## DECISION OF THE PLANNING ADMINISTRATOR

**SUBDIVISION / CLASS 2 ADJUSTMENT CASE NO.: SUB-ADJ19-07**

**LOCATION:** 5775 Commercial Street SE

**BEFORE THE PLANNING ADMINISTRATOR  
OF THE CITY OF SALEM  
(SUBDIVISION PLAT NO. 19-04)**

**TENTATIVE SUBDIVISION PLAN**

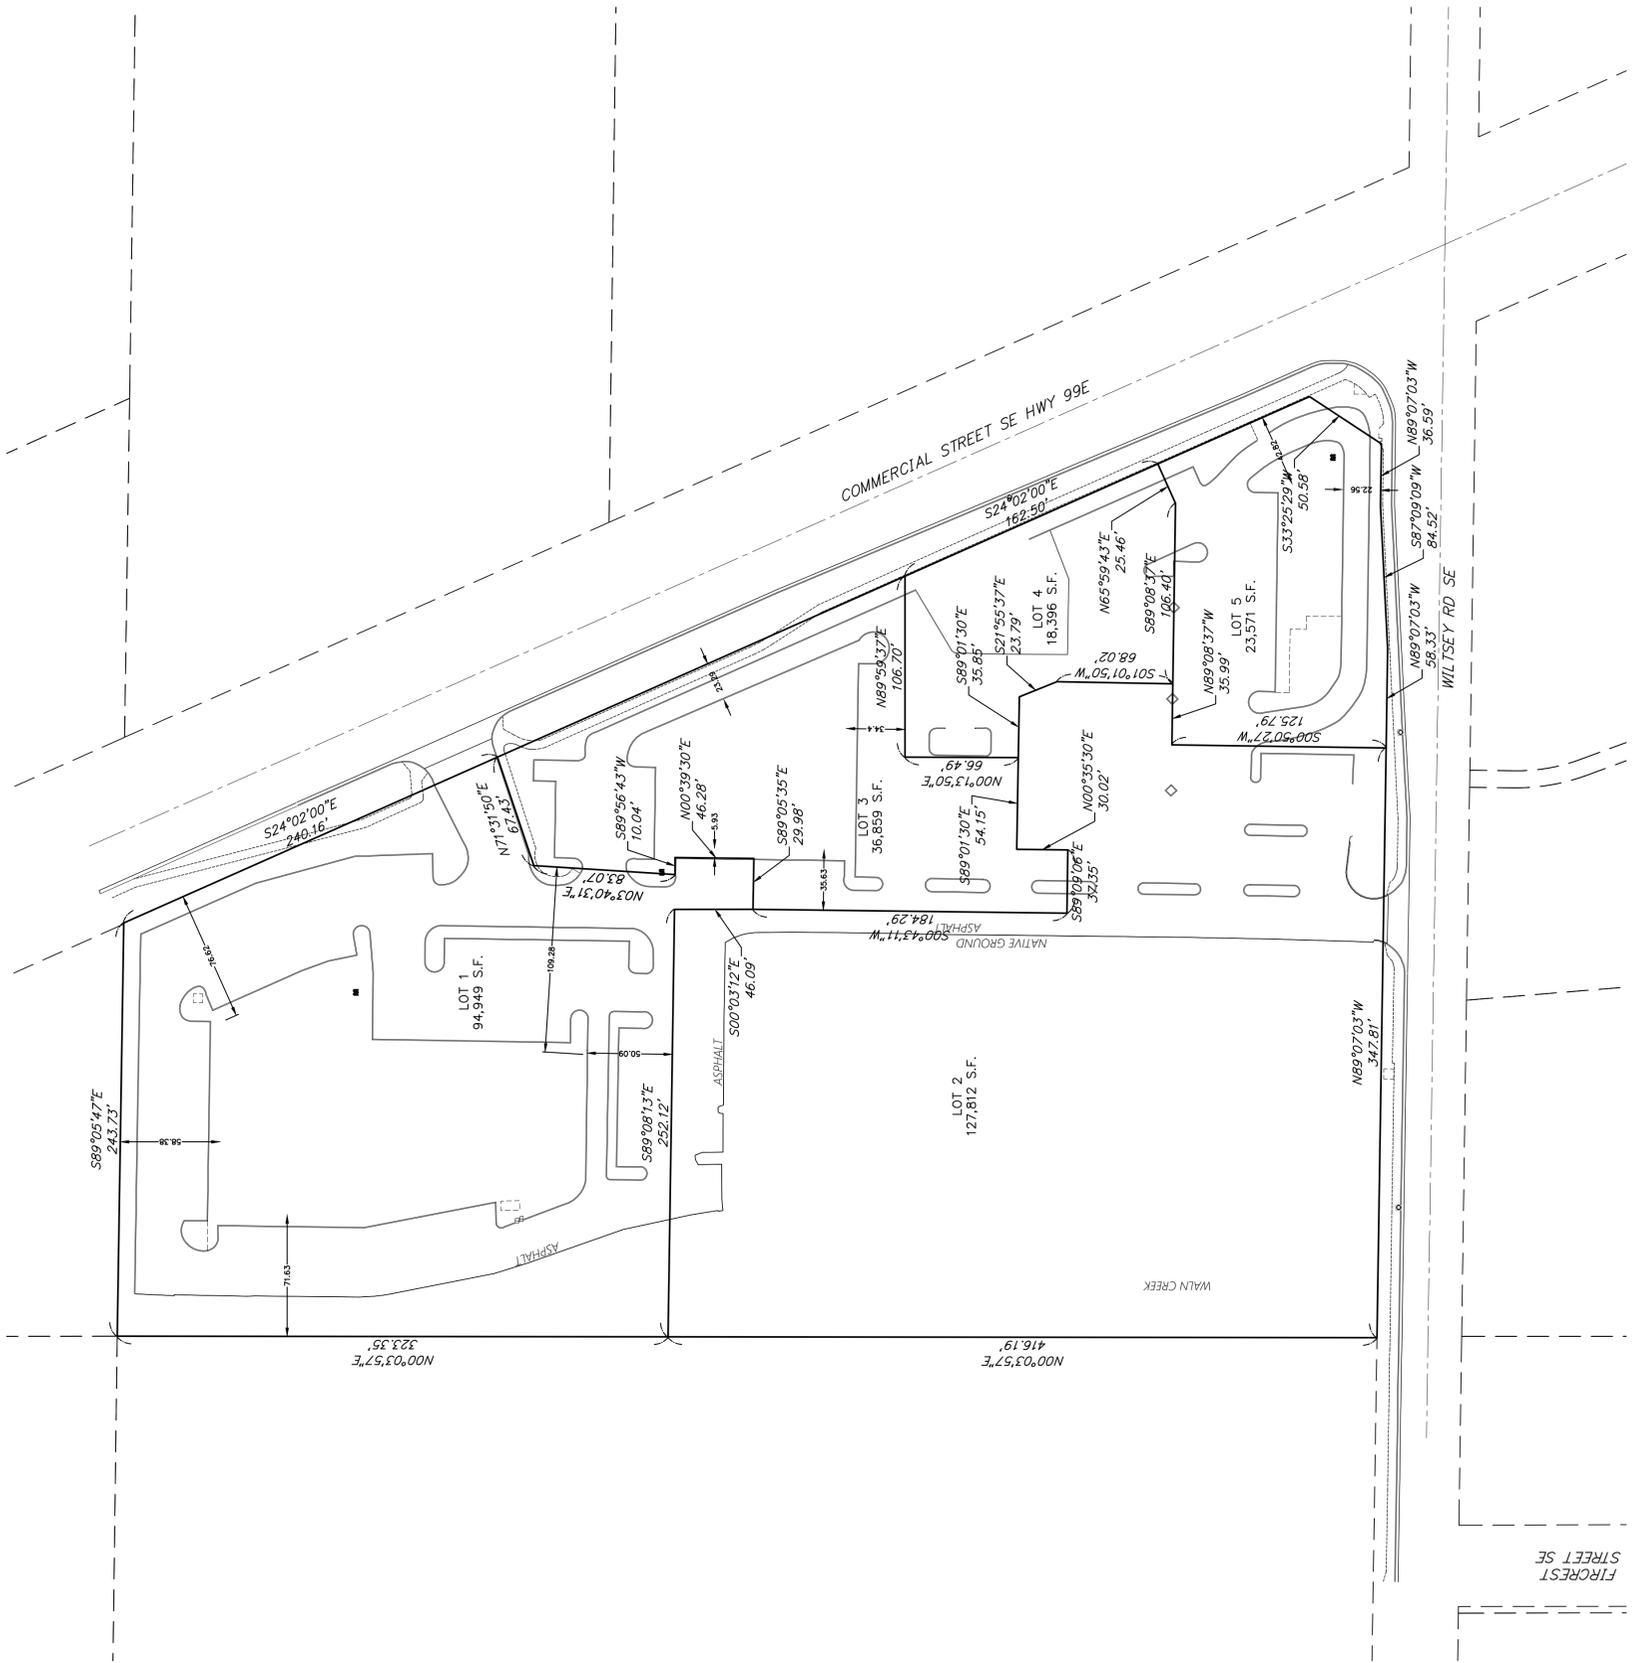
The tentative plan proposes to divide the property, which consists of four tax lots, into five lots (Attachment B). The lots range in size from approximately 0.42 acres to approximately 2.93 acres. All lots take access directly from public streets and Lot 1,

Lot 1 and Lots 3-5 will contain an existing commercial development that share access and parking areas. The proposed lot line will not meet the standards for landscaping and setbacks to property lines from vehicle use areas. The applicant has applied for a Class 2 Adjustment, which is addressed below in Section 8.

The subject property has previously abandoned a sewer main located within the subject property. The easement for the main is still shown on the subject property. In order to eliminate the easement, the applicant shall obtain City approval for quitclaim of abandoned City infrastructure easements located on the subject property.

Waln Creek is located within the subject property. This portion of the creek was not analyzed in conjunction with the Flood Insurance Study. The proposed subdivision is greater than 5 acres; therefore, the applicant shall provide an engineered analysis along Waln Creek abutting the subject property to determine the base flood elevations and floodway boundaries pursuant to SRC 601.110(a)(5).

As shown on the site plan, the proposed property lines run through the parking areas located within the development. Therefore, the applicant is requesting a Class 2-Adjustment to this standard.

**Condition 1:** Prior to final plat, the applicant shall obtain City approval for quitclaim of abandoned City infrastructure easements located on the subject property.

**Condition 2:** Prior to final plat, the applicant shall design and construct water, sewer, and stormwater systems and provide access and utility easements to serve all proposed lots in compliance with PWDS and ORS 92.090.

**Condition 6:** Prior to plat, provide an engineered analysis along Waln Creek abutting the subject property to determine the base flood elevations and floodway boundaries.

**Condition 7:** Prior to final plat, the applicant shall provide a parking and access agreement for all five lots.

**Condition 8:** Prior to final plat, the applicant shall provide and receive approval from the Planning Division for a landscaping plan including required landscaping and additional 252 plant units.
